STAFF REPORT AMENDED 7-26-84
CITY PLANNING COMMISSION

APPLICATION: 1. Negative Declaration
2. Plan Review for a 20 unit apartment in the Garden Apartment - Review (R-2A-R) zone. (Sec. 13-A-(4))

LOCATION: 511-531 Wilson Avenue

APPLC. NO. P84-231

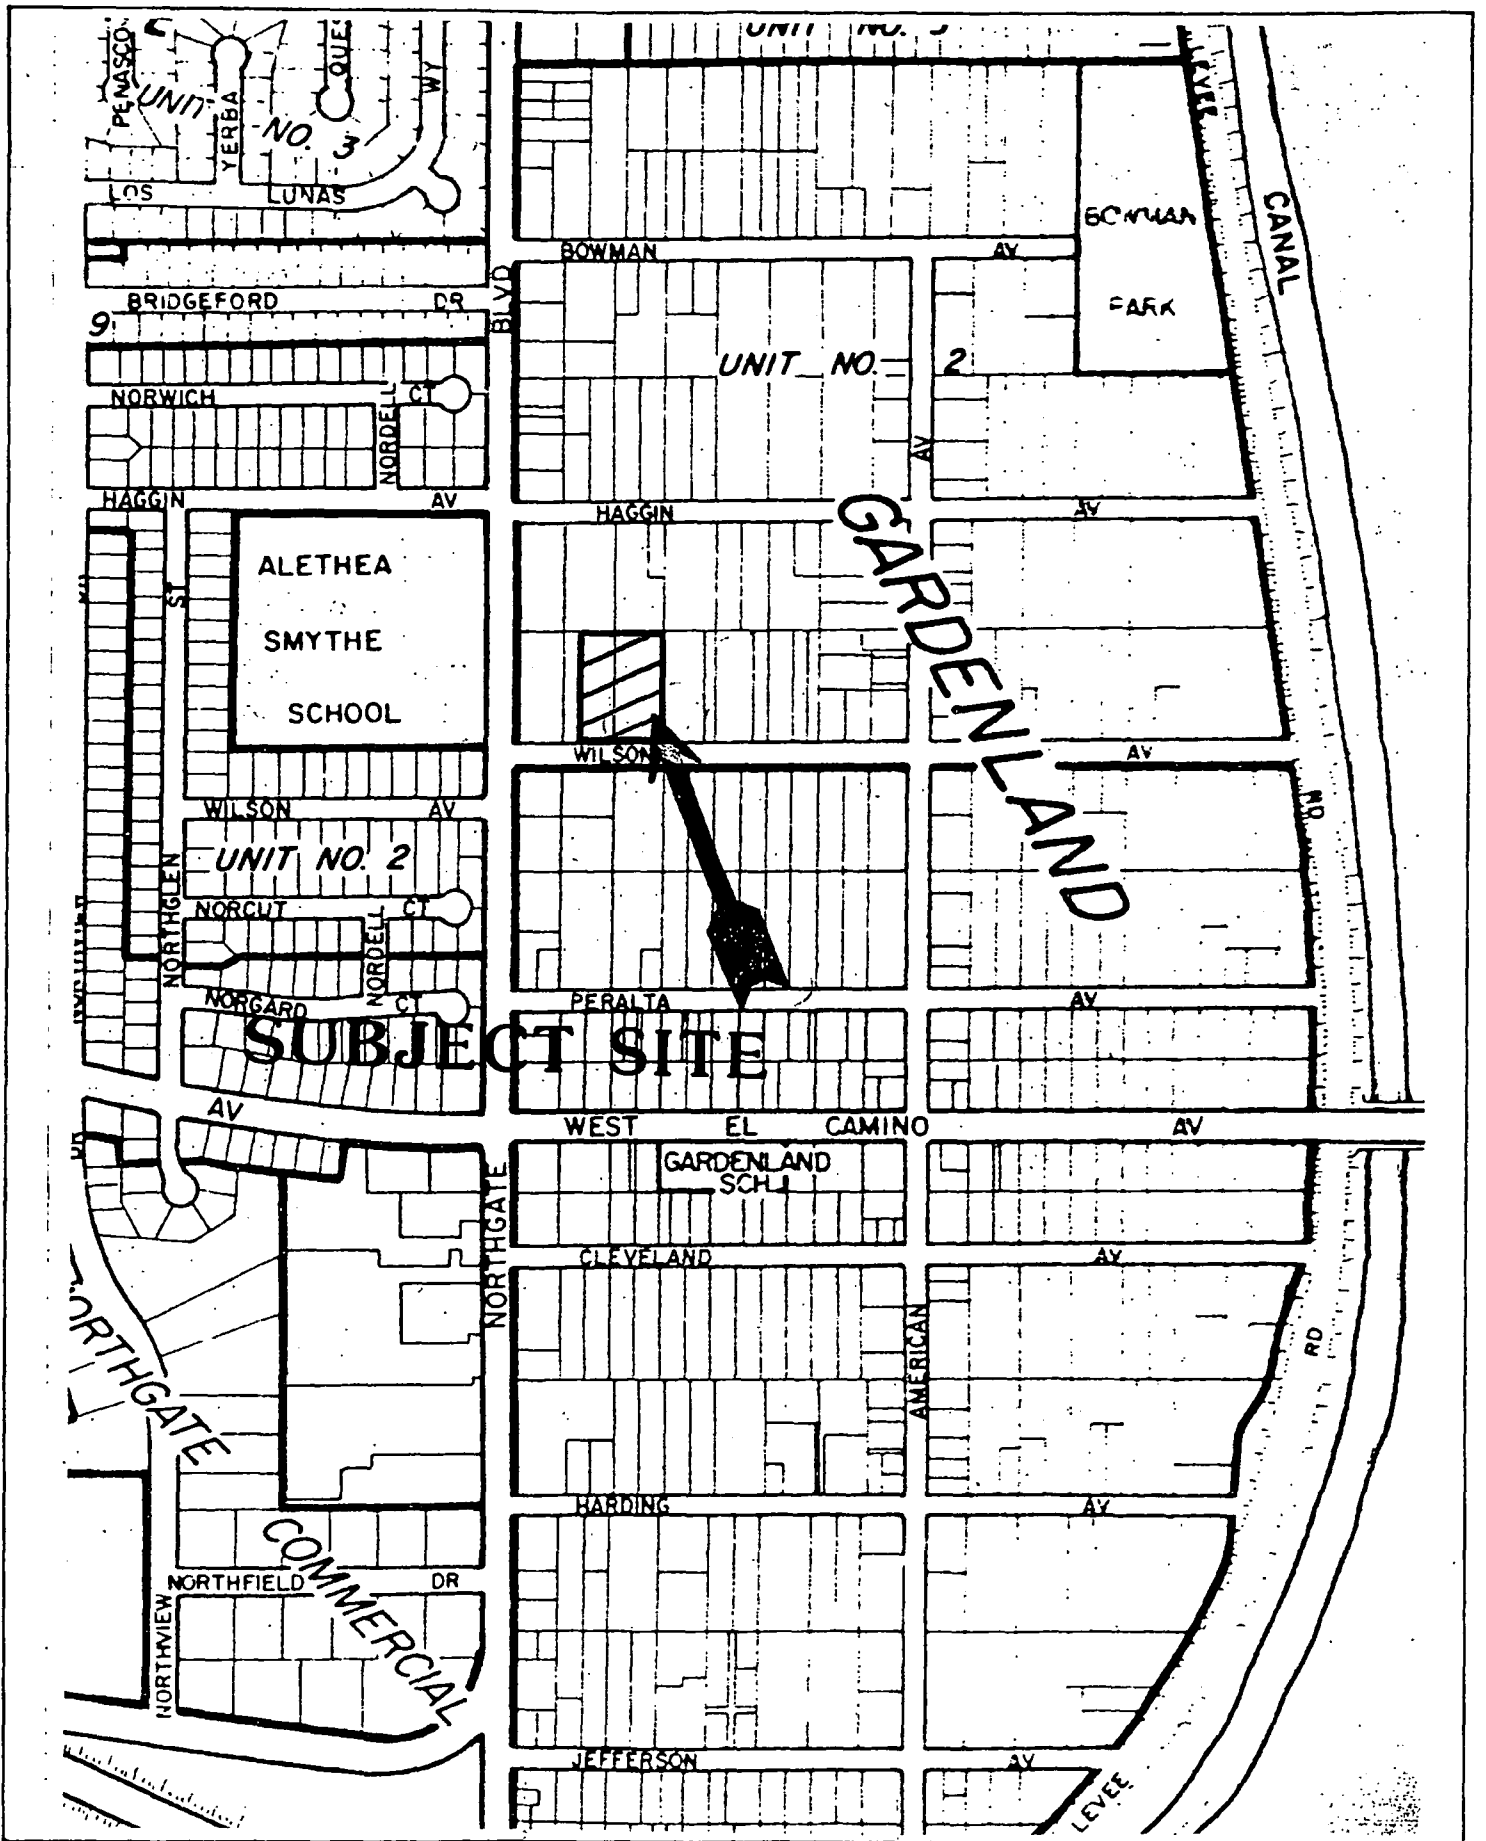
2. The site plan indicates that seven structures will be developed in clusters around a private cul-de-sac in the center of the site. The site will be developed with varied building sizes and configurations which help to provide a more interesting site design. Staff does, however, have concern over the building elevations which lack detail and visual interest. The applicant is proposing to use stucco exterior throughout the project, which will distract from the overall site design. Staff, therefore, recommends that the applicant utilize horizontal wood siding as the exterior finish for the recreation building and the apartment structure located on the southwest corner of the site. In an effort to create interest in the front elevations, staff also recommends the use of greenhouse windows in the kitchen area of each unit or some other window treatment that will assist in providing relief and interest to these elevations.

4. The applicants plans do not indicate the material and design of the on-site trash enclosure. Staff recommends the applicant submit detailed plans of the trash enclosure for staff review and approval. This trash enclosure should be six feet in height and constructed of a masonry material.

- 3. Revised landscape plans indicating the location and type of deciduous trees to be added on the south, east and west sides of the structures shall be submitted for staff review and approval. The minimum size of all trees to be used on the site shall be 15 gallon containers.

- * 1. *The applicant shall modify the plans by providing horizontal wood siding on the recreation building and the apartment building located on the southwest corner of the site. Modified plans shall be submitted to planning staff for review and approval prior to issuance of a building permit. The plans shall also indicate the use of greenhouse windows in all kitchen areas or some other type of window treatment that will relieve the monotony of the front elevations.*

- 2. The applicant shall submit detailed plans for the on-site trash enclosure for staffs review and approval prior to issuance of a building permit. The trash enclosure shall be six feet in height and consist of a masonry material.
